Clarification Responses

ROYAL NAVAL MUSEUM
PHASE 1, PORTSMOUTH
Victory Gallery -
Fire Fighting Equipment Plans

Drawing No: 90.105.177

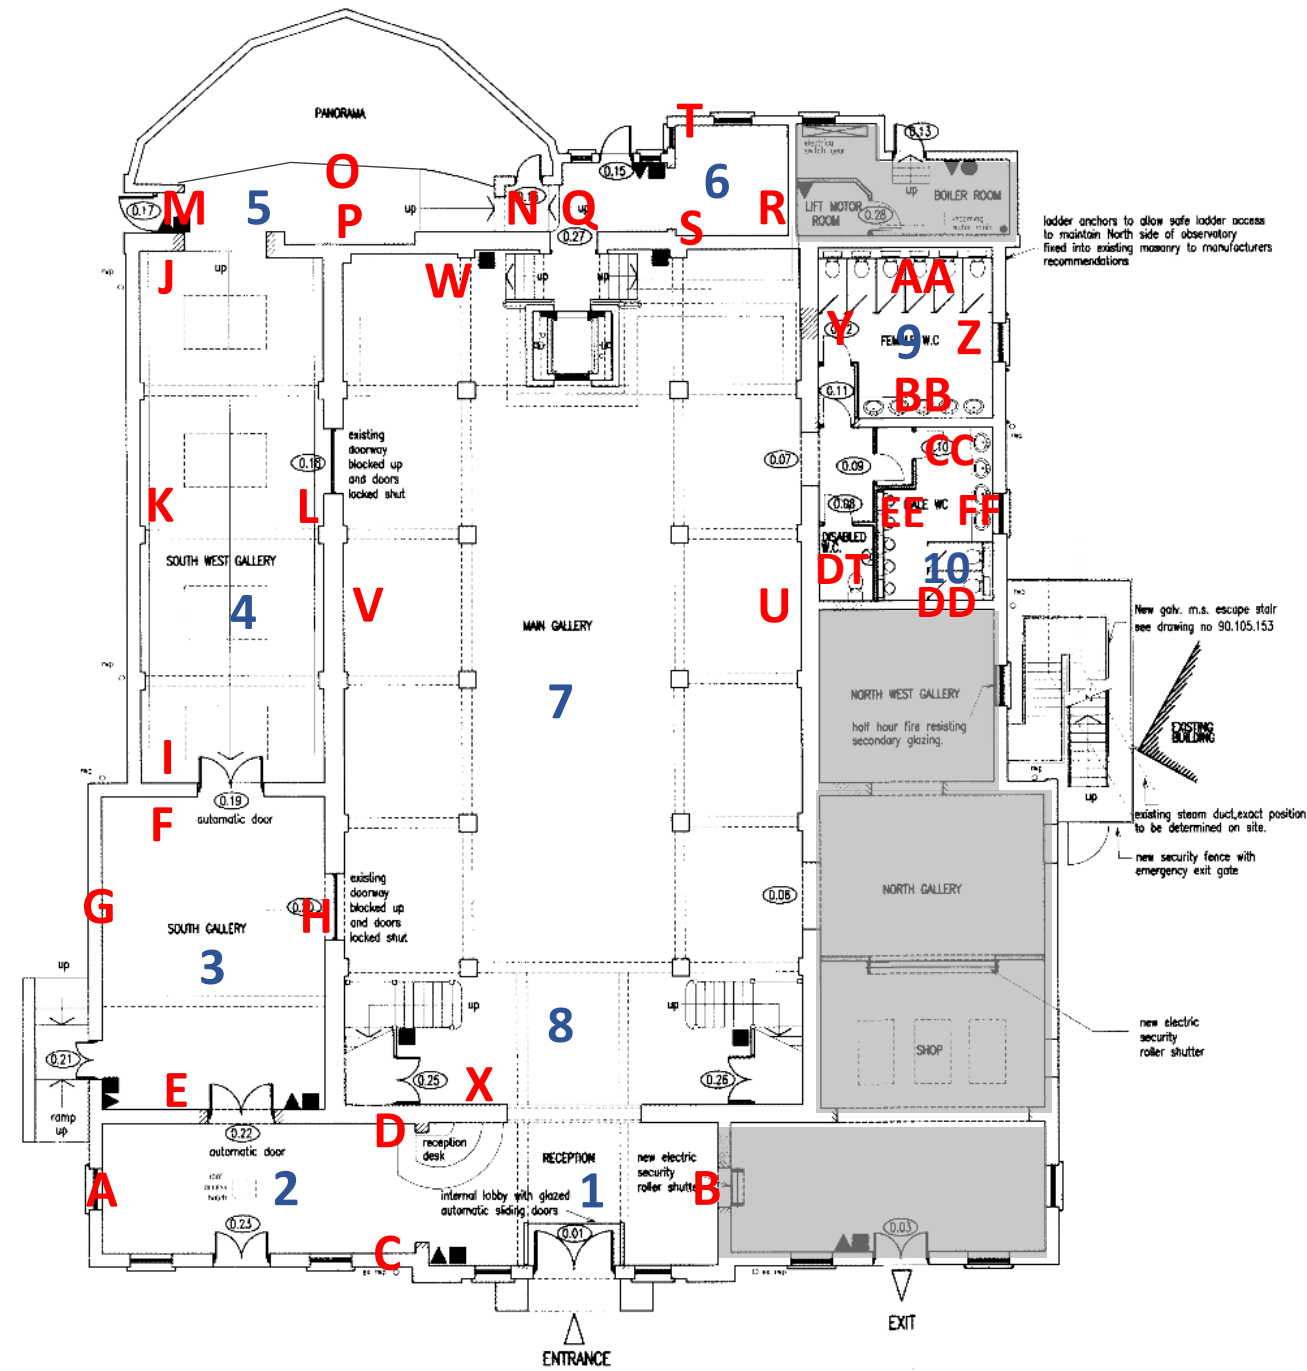
Please note that these measurements are approximate based on a laser distance survey of the building completed on the 5th August 2019.

Ground floor			Second floor			Height	
Point	to Point	Distance (meters)	Point	to Point	Distance (meters)	Area	Distance (meters)
A	B	17.4	GG	HH	8	1	3.6
C	D	3.9	II	JJ	4	2	3.9
E	F	8.8	II	KK	8	3	4.1
G	H	4.7	LL	MM	21.7	4	4.6
I	J	14.6	NN	OO	3.4	5	2.1
K	L	4.3	PP	QQ	3.7	6	2.9
M	N	9.6	RR	SS	3.5	7	8.5
O	P	1.7	TT	UU	14.8	8	3.6
Q	R	7.9	VV	WW	4.8	9	3.3
S	T	2.7				10	3.3
U	V	12.8	Disabled Toilet (DT)			11	5.4
W	X	23.9	Width	1.6		12	4.7
Y	X	4.8	Length	2			
AA	BB	4.8	Height	2.9			
CC	DD	4.8					
EE	FF	2.9

Height to current suspended ceiling
